December 16, 2016

Project Name: **Westerlea View Lofts: 54 unit residential development plus 1 commercial space**  
Project ID: #2016-184 (Subdivision & Site Plan) and  
#2016-185 (Conditional Use Inclusionary Zoning)  
Address: 75 Chestnut Street CBL: 26/E/10  
Applicant: A&M Partners Inc  
Planner: Jean Fraser

## PLANNING BOARD REPORT PORTLAND, MAINE

Project #2016-184 (Subdivision & Site Plan) Project  
#2016-185 (Conditional Use Inclusionary Zoning) CBL:  
26/E/10

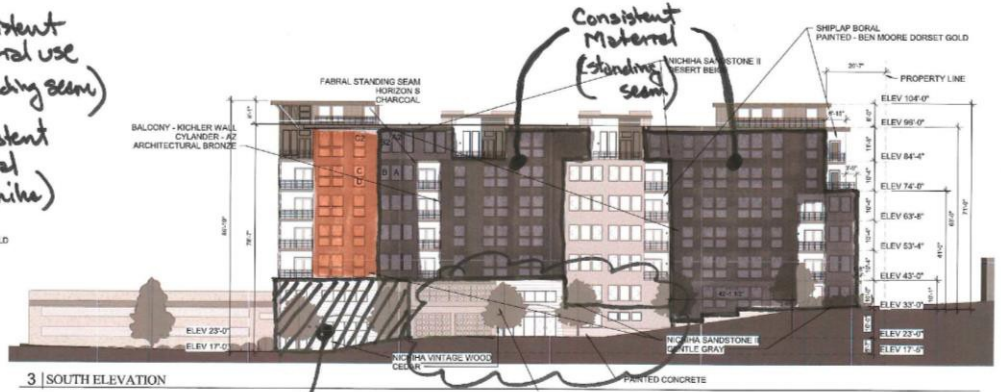
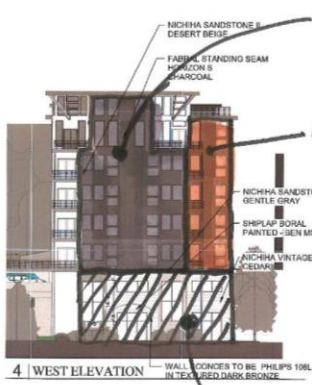
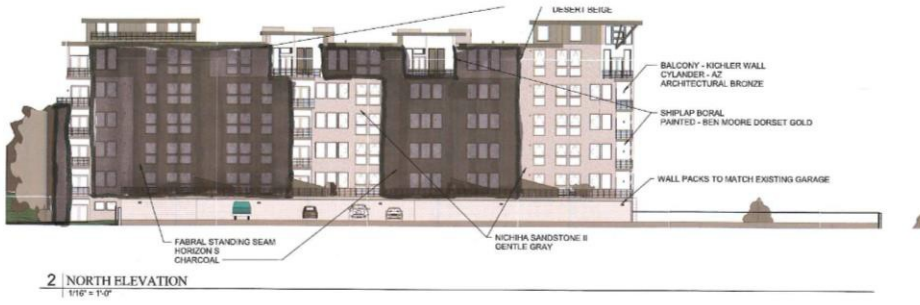
- The base of the building should be more consistently defined, especially on the Chestnut Street side. At this point, that can best be achieved through articulation, material placement and detailing. The corner, double-height live-work unit could also be more substantially differentiated from the other masses of the building.

- The level of detail and articulation on the Chestnut Street elevation is not sufficient, especially at the street level. Material changes are mostly arbitrary and other than at the entrance, do not correspond to uses or plane changes. Revisions to meet this standard could come in form of enclosure; articulation and detail (reveals, dimensional trim, material transitions, detail); placement of material that corresponds with uses

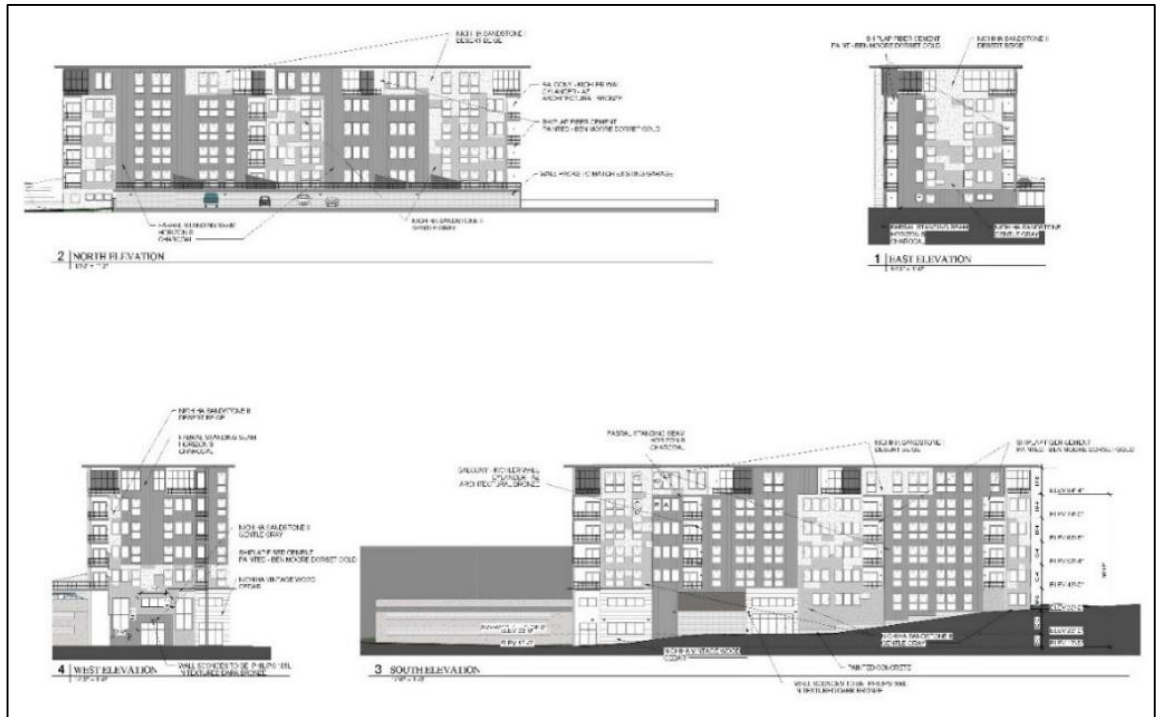
*The base of the building which relates to the pedestrian realm shall be designed with a high level of detailing and material quality utilizing the options listed above. . . . Buildings which are six and seven stories shall meet this standard on the first 24 feet, or the first two floors at a minimum.*

- The level of detail and articulation on the Chestnut Street elevation is not sufficient, especially at the street level. Material changes are mostly arbitrary and other than at the entrance, do not correspond to uses or plane changes. Revisions to meet this standard could come in form of enclosure; articulation and detail (reveals, dimensional trim, material transitions, detail); placement of material that corresponds with uses.

(see sketch in Attachment 2 annotating the elevations to clarify the comments)
